**LEBANON PLANNING BOARD
APRIL 11, 2022 - 6:30 PM
COUNCIL CHAMBERS, CITY HALL OR
REMOTE VIA VIRTUAL PLATFORM
LEBANONNH.GOV/LIVE**

April 11, 2022 Meeting

Staff Memorandum – PB2022-10-SPR/PB2022-02-CUP – *con't from 2/22/22*

Subject: **Site Plan Review Application – Oakes Storage, LLC**
 92 Riverside Drive (Map 111 – Lot 16); Lebanon, New Hampshire
 KNA Project No. 21-1216-2

LIGHTING PLAN
SHEET L-2

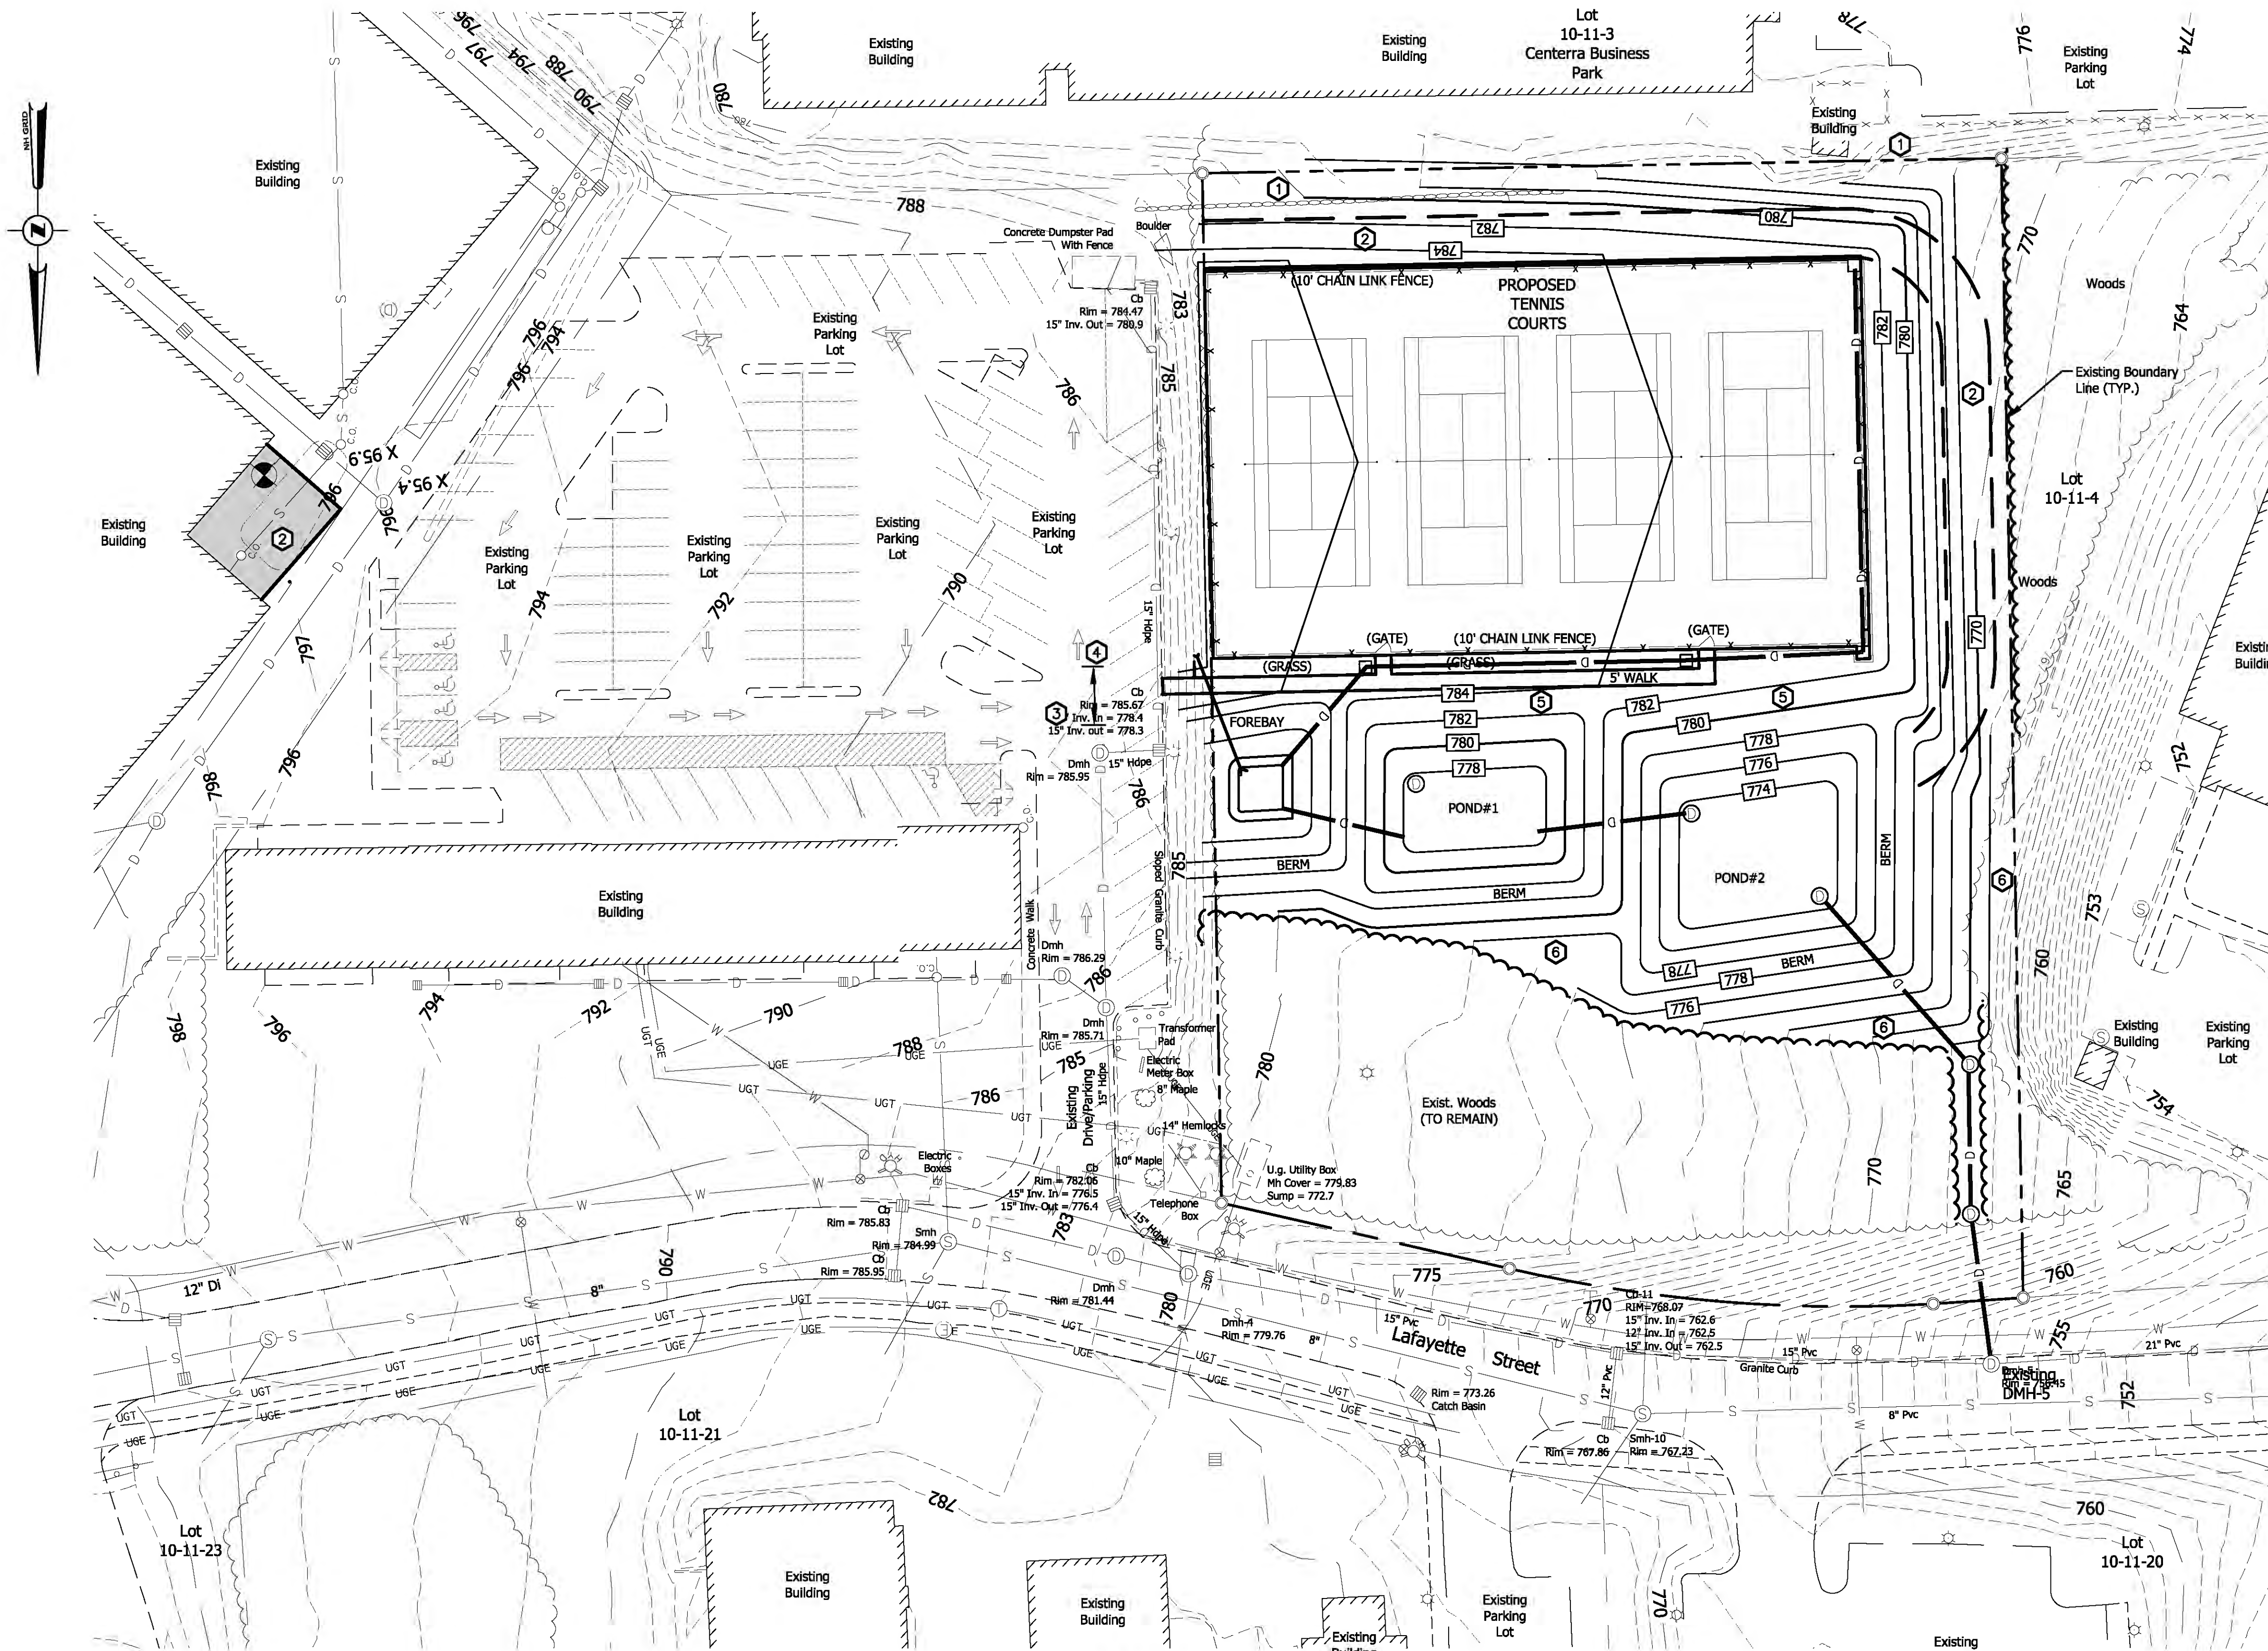
- c) On Sheet L-2 (Lighting Plan), per Section 5.1.E.13:
 - i. Identify light intensities and compliance with Section 6.7.B.2 ("The light intensity at adjoining streets or commercial property boundaries shall not exceed 0.5 foot-candles at grade level[.]")

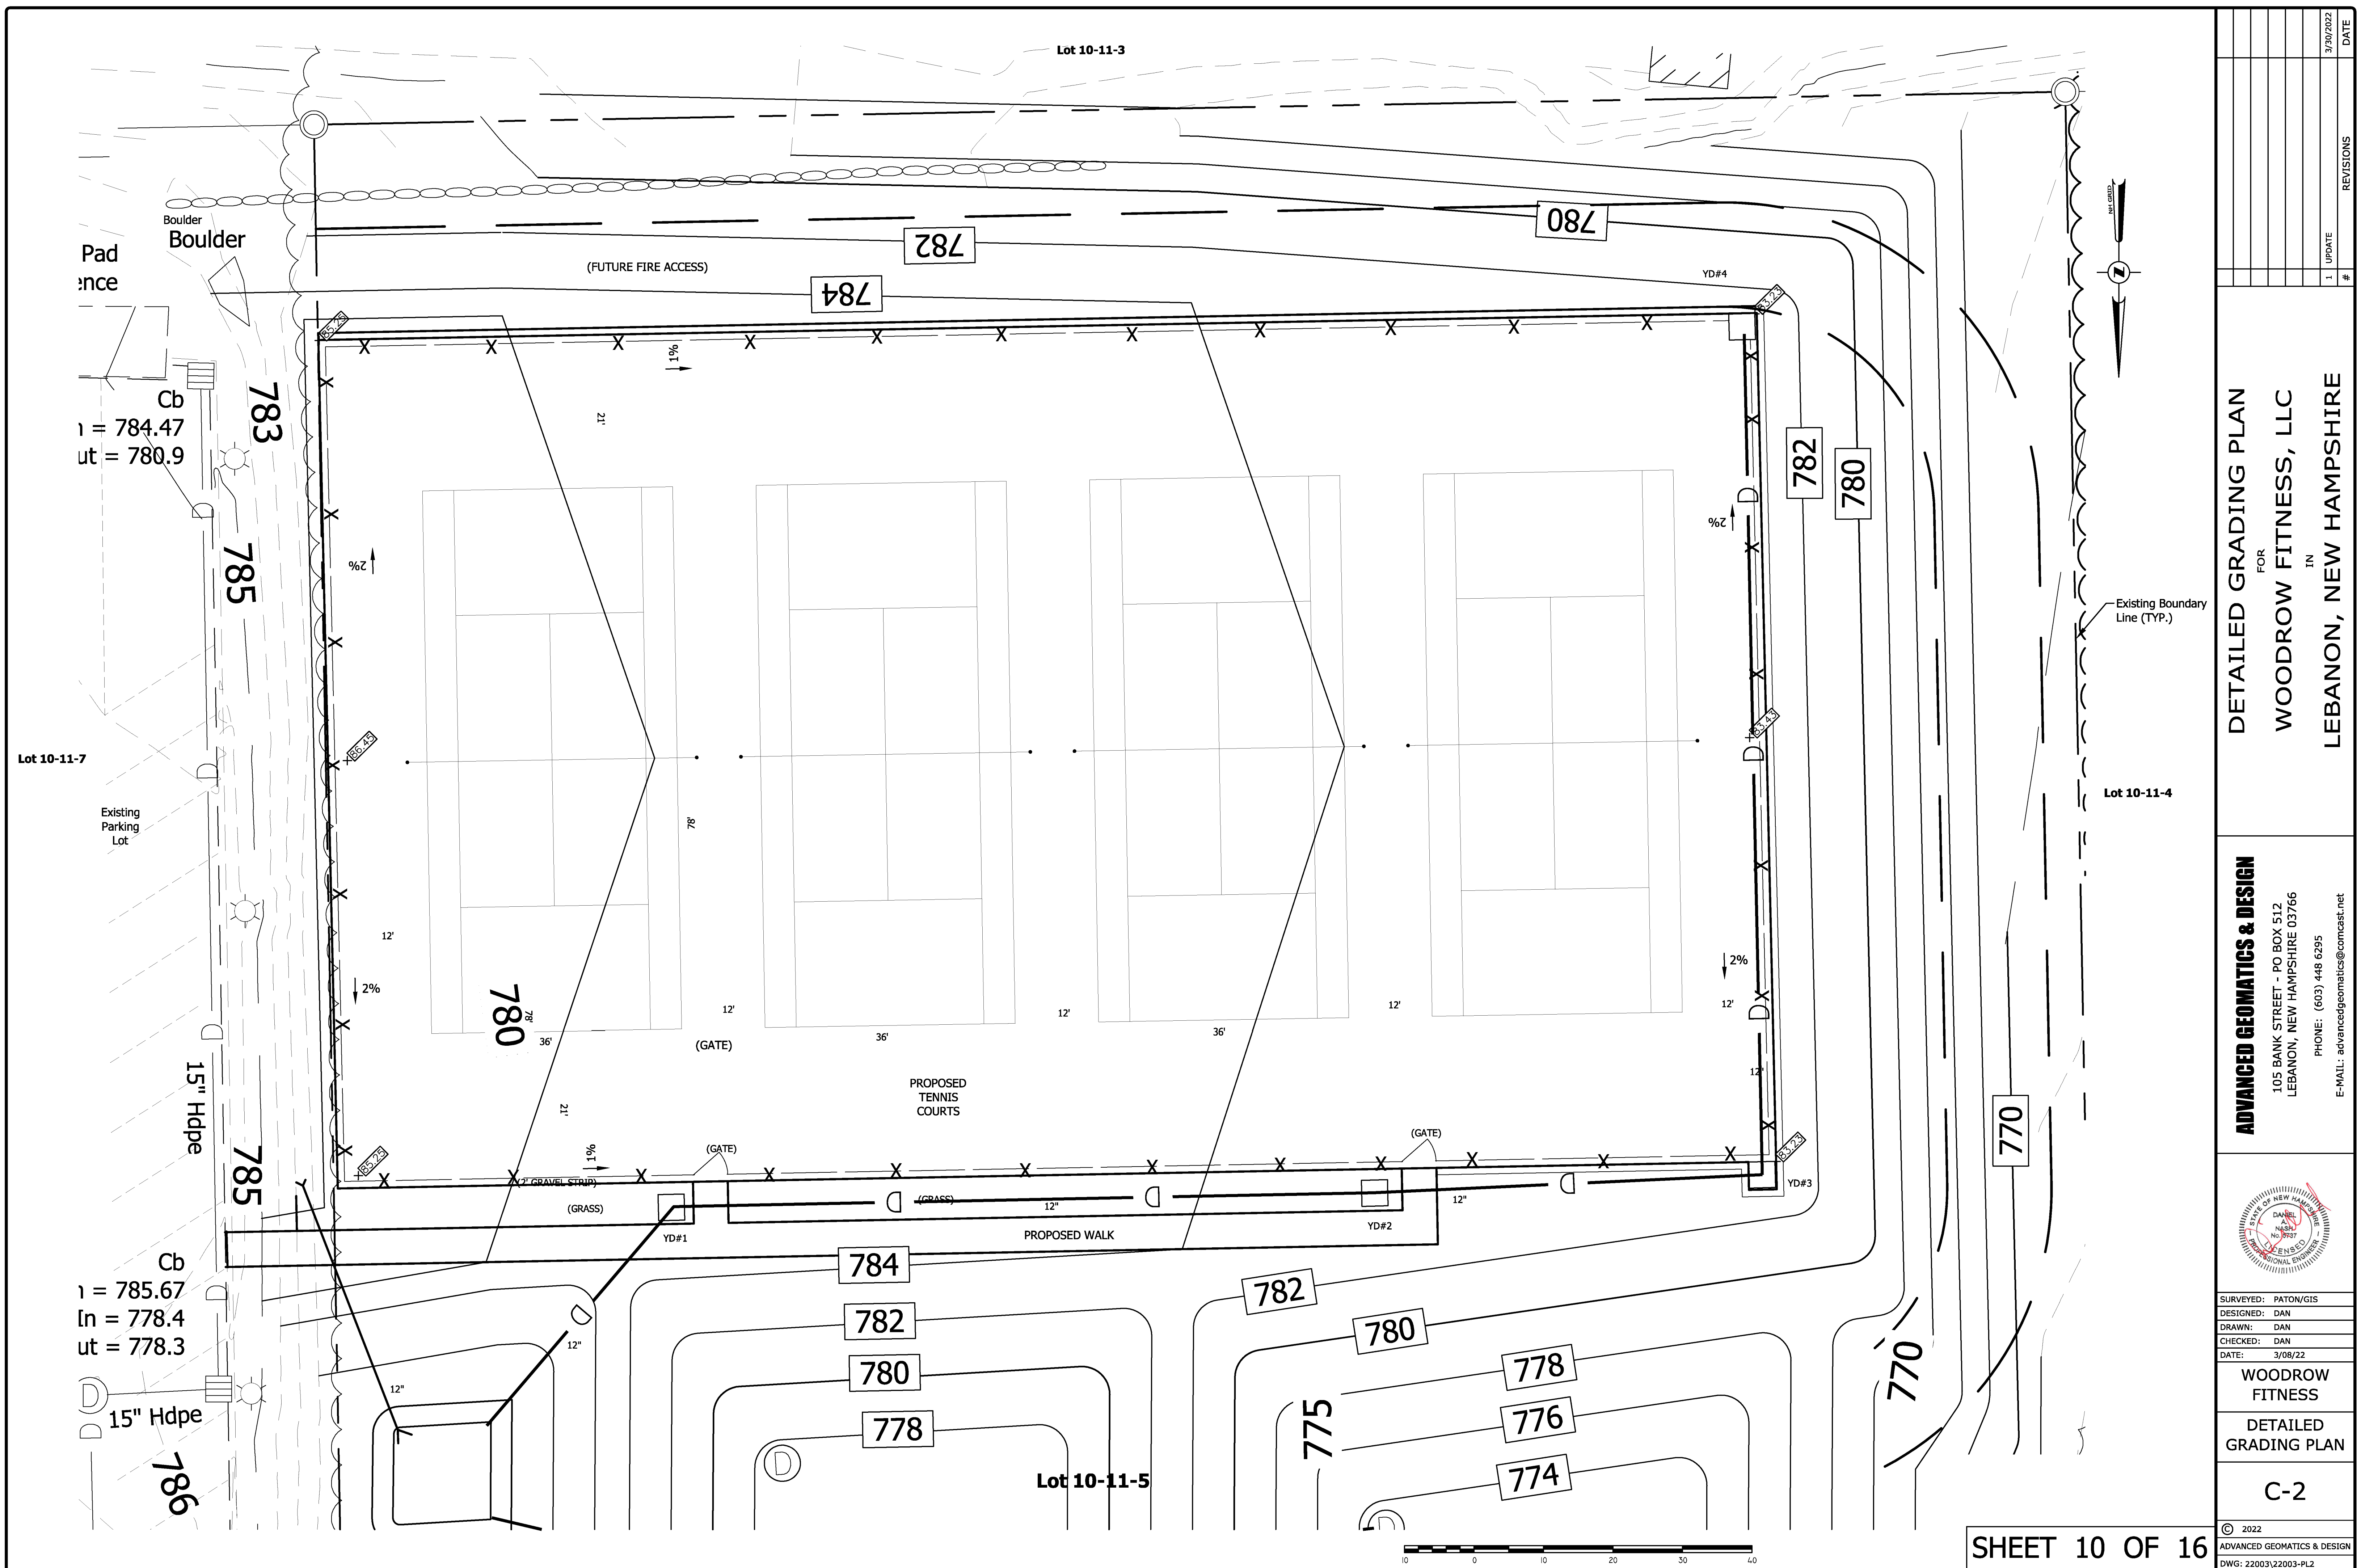
15. Identify location of proposed fence that will enclose the tennis courts.
16. Sheet 8 is very difficult to read, and it is not clear what many of the lines and markings are intended to represent. For the benefit of the Planning Board members and the site plan review process, please use this sheet to show only the above-ground proposed physical improvements without existing conditions that are proposed to change.
- a. Please consider other ways to make the site plan sheet more understandable to a layperson including but not limited to any one or more of the following:
- Use a larger scale
 - Provide a legend
 - Provide additional labeling
 - Use shading
 - Use coloring

Item 10. Existing wooded area. The landscaping plan is intended to focus on the area receiving plantings. The site plan, Sheet C-1, indicates wooded area to remain.

Item 16. Sheet 8. Sheets C-1 thru C-4 and ECP-1 have been modified to have existing contours removed from under the proposed site.
